Access Compliance Report

Public Rights-of-Way

(Curb Ramps)

Intersection ID: 3101	Main Street: ALABASTER_CT	Cross Street: MINERAL_RIDGE_WY	Location:	N
ADA ID: F53A0E0FDB1C	Ramp Type: Perp	Initial Pass/Fail: Fail	Overall Compliance: No	Severity Score: 10
Codes/Mitigation Info/Possible Solution		Field Measurements/Component Compliance

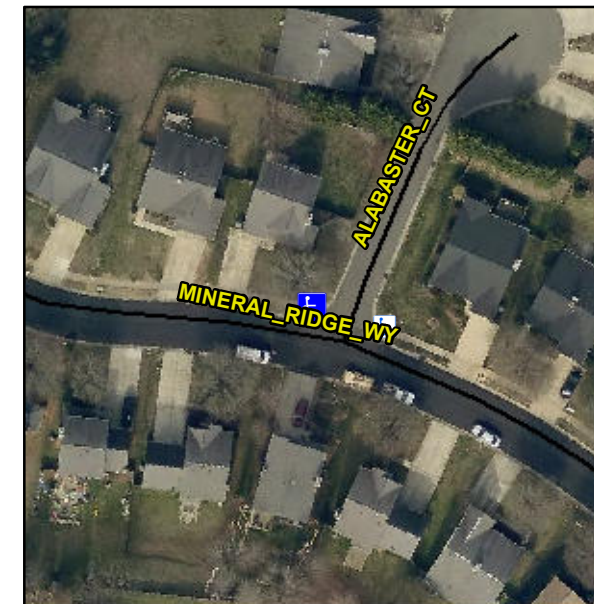
Not Found, R304.5.1, R304.5.3

Compliance	Description	Data	Compliance	Description	Data
N/A	Ramp Length (in)	51.0	Yes	Ramp Slope (%)	5.1
No	Ramp Width (in)	46.5	No	Ramp XSlope (%)	3.5
N/A	Flare Type LT	N/A	N/A	Flare Type RT	N/A
N/A	Flare Slope LT (%)	N/A	N/A	Flare Slope RT (%)	N/A
N/A	Flare Traversable LT?	N/A	N/A	Flare Traversable RT?	N/A
N/A	Landing Length (in)	N/A	N/A	DWS Provided?	N/A
N/A	Landing Width (in)	N/A	N/A	DWS Contrast?	N/A
N/A	Landing Slope (%)	N/A	N/A	DWS Length (in)	N/A
N/A	Landing X Slope (%)	N/A	N/A	DWS Full Width?	N/A
N/A	Landing Curb? (Y/N)	N/A	N/A	DWS Offset (in)	N/A
N/A	Shared Landing?	N/A			
N/A	Gutter Ponding?	N/A	N/A	Gutter Slope (%)	N/A
N/A	Gutter Lip Ht (in)	N/A	N/A	Gutter X Slope (%)	N/A
N/A	Painted X Walk1?	No	N/A	Painted X Walk2?	N/A
	X Walk 1 Direction	To SE		X Walk 2 Direction	N/A
N/A	X Walk 1 Width (in)	N/A	N/A	X Walk 2 Width (in)	N/A
	X Walk 1 Slope (%)	3.7		X Walk 2 Slope (%)	N/A
	X Walk 1 X Slope (%)	1.9		X Walk 2 X Slope (%)	N/A

Remove & Replace Entire Ramp.
